Drawing Status:	Approval
Proposed Floor and Roof Plan

insight
Architectural Design
West High Ridge Annex
Work
Hexham, NE48 3BW

Scale: 1/100 @ A3 Date: Dec'22
Drawn: JT Auth: [Signature]
22WHRA (GA) 01-04 A

(GA) 04 Proposed Roof Plan

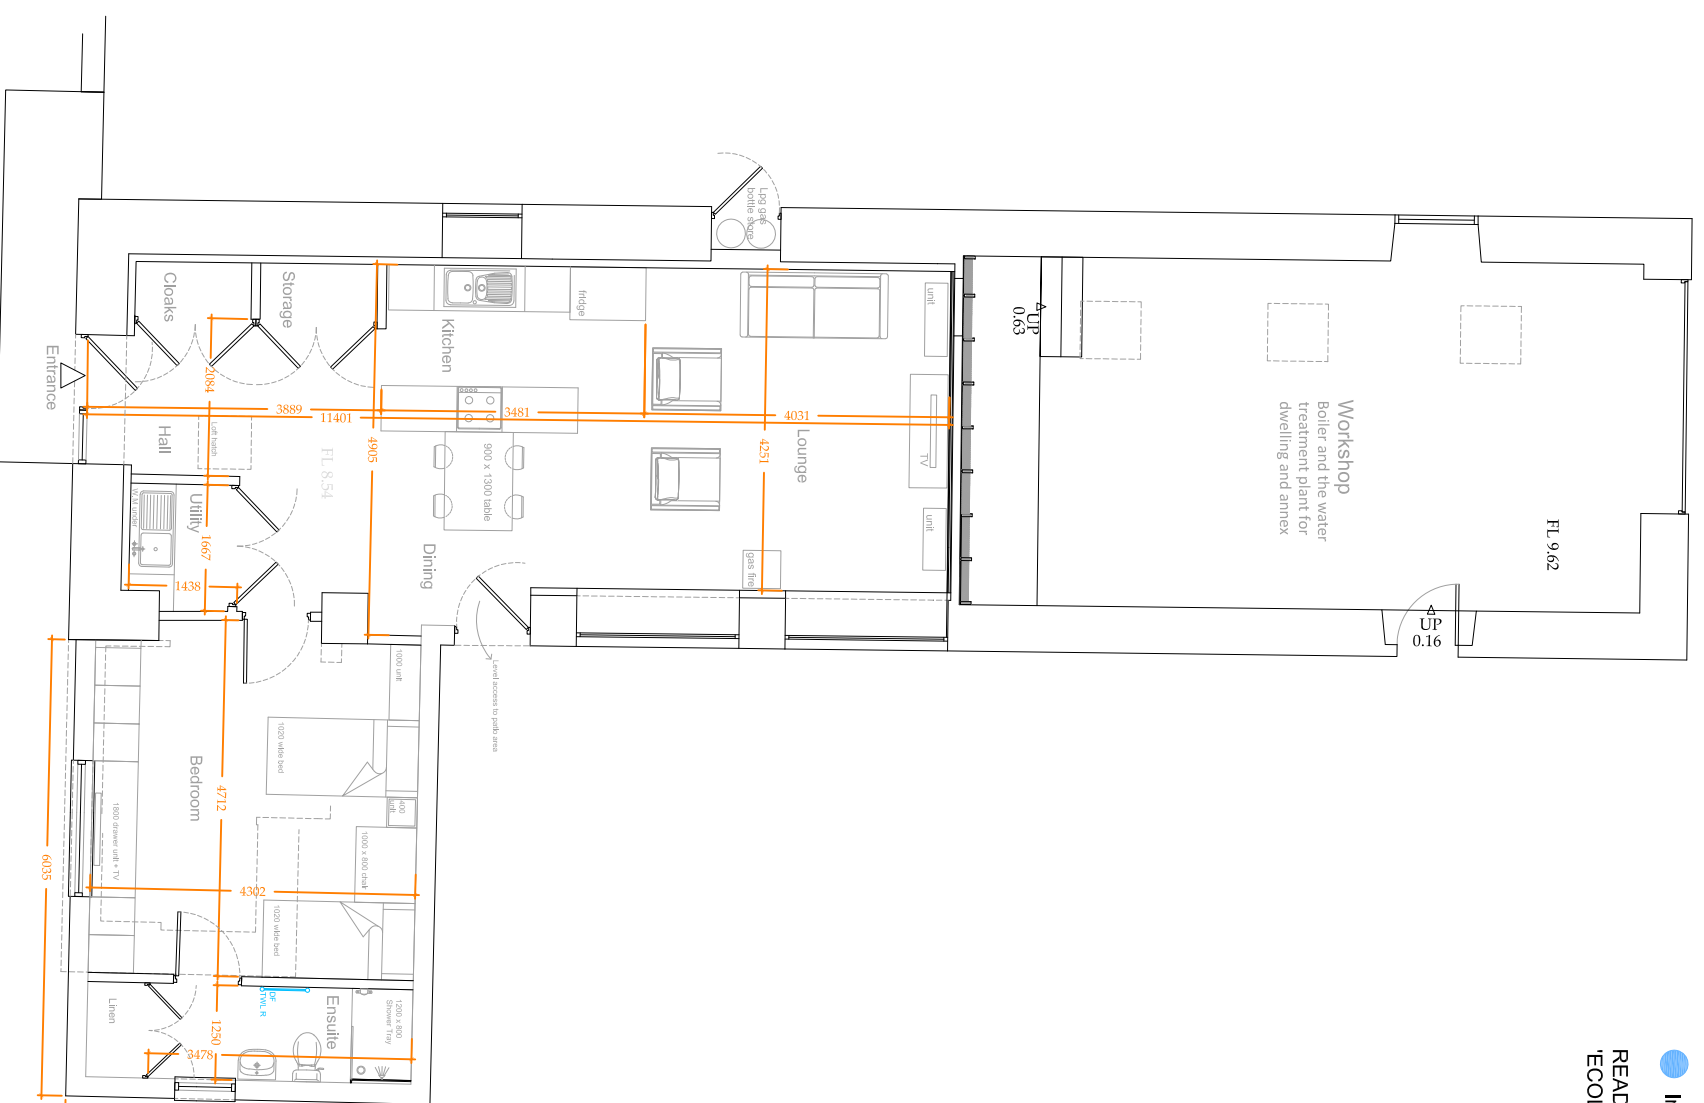
Ecology Mitigation

- Crevices on main roof and behind hanging slates retained
- Inbuilt bat box location

Revision	Description	Date
A	Ecology mitigation added	01/02/23
